AMENDMENT OF SOLICITATION/MODIFICATION OF CONTRACT				1. CONTRACT ID CODE J		PAGE OF PAGES 1 3	
2. AMENDMENT/MODIFICATION NO. 0001		3. EFFECTIVE DATE 20-Dec-2002		4. REQUISITION/PURCHASE REQ. NO. W26GLG-2302-2968		5. PROJECT NO.(If applicable)

14. DESCRIPTION OF AMENDMENT/MODIFICATION (Organized by UCF section headings, including solicitation/contract subject matter where feasible.) Solicitation No. DACW65-03-R-0008, Jamestown Island Shoreline Protection, Jamestown Island, VA is amended as follows: Solicitation notice is changed to read: 1. Technical POC is Mark Hudgins, 757-441-7107 2. Replace 4th sentence with: "The Contractor shall be required to maintain the waterway work areas in a manner to ensure the safe passage of the public for the duration of the contract." <div style="text-align: center;">SEE CONTINUATION PAGES</div>							
<small>Except as provided herein, all terms and conditions of the document referenced in Item 9A or 10A, as heretofore changed, remains unchanged and in full force and effect.</small>							
15A. NAME AND TITLE OF SIGNER (Type or print)				16A. NAME AND TITLE OF CONTRACTING OFFICER (Type or print)

SITE 1-1 SECTION DETAIL 1

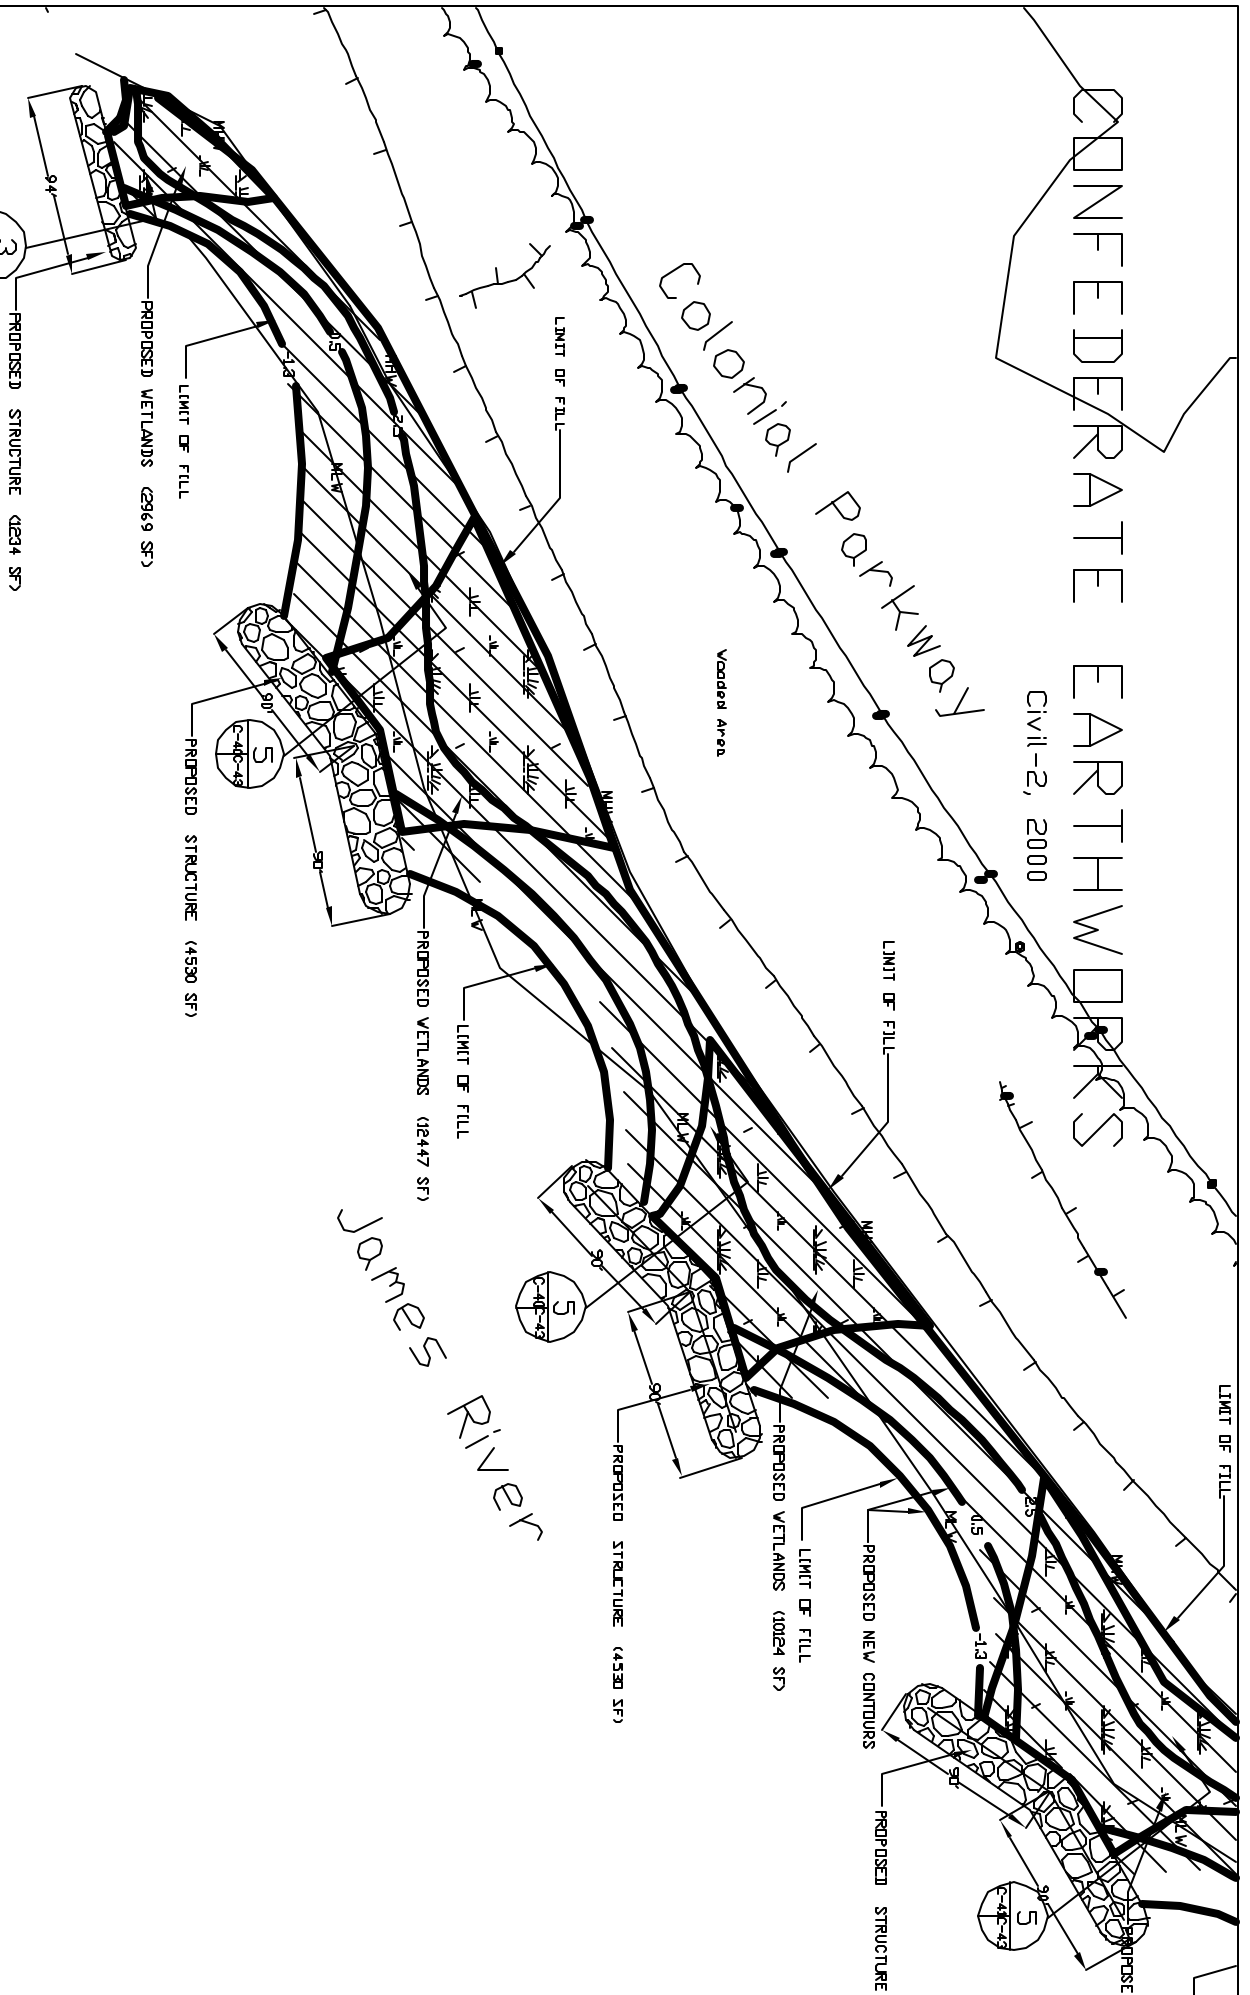
5. Specification Section 02936, Establishment of Marshgrass, para. 2.1, 1st sentence, delete “collected or”.
6. Sheet 20 (C-19) Change detail section from 2 to 5.
7. Sheet C-40 and C-41 See (Sheet C-40 Amend 1, Attachment C and Sheet C-41 Amend 1, Attachment D) for clarifications.
8. Sheet 44 (C-43) Use VDOT Class I graded riprap for bedding stone under structure. Replace detail 1 with (Revision 1 Detail Sheet, Attachment B).
9. Added note to Sheet 44 (C-43) “Sandfill shall be placed only on those sites that have vegetation as indicated on the plan view.”
10. There are no borings along the different site locations. The only geotechnical information is included in Appendix A.
